Original Date: 010300  
Issue Date: 010300  
Version No: 0  
Date Modified: N/A

The armature assemblies for the MS600P and MS700PS have changed as of 1 January, 1998. The new part numbers for the gearbox, armature and bearings of both models are as follows:

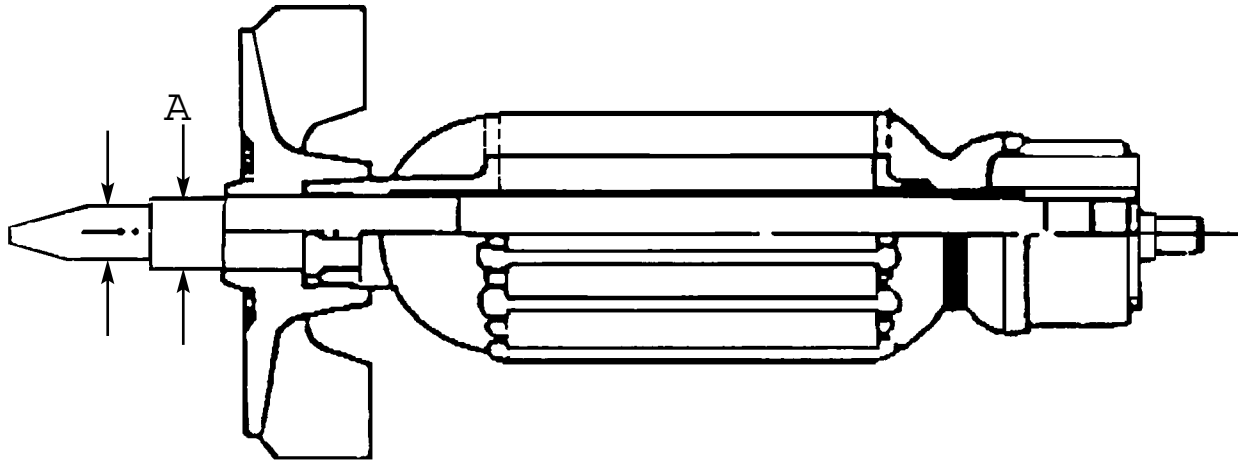
Description	Part No.	Change	
<b>Both models:</b>			
Old Gearbox	332/13452.1011	Ø35mm	
New Gearbox	332/13452.1012	Ø32mm	
Old Bearing	B/6300ZZ		
New Bearing	B/6201ZZ		
<b>MS600P</b>		ØA	ØB
Old Armature	332/13452.9037	10mm	10mm
New Armature	332/13452.9137	12mm	11.2mm
<b>MS700PS</b>			
Old Armature	332/13452.9036	10mm	10mm
New Armature	332/13452.9136	12mm	11.2mm

Note that the old parts listed are NO LONGER AVAILABLE. For old machines needing any of these parts, order all three new parts as a replacement assembly.
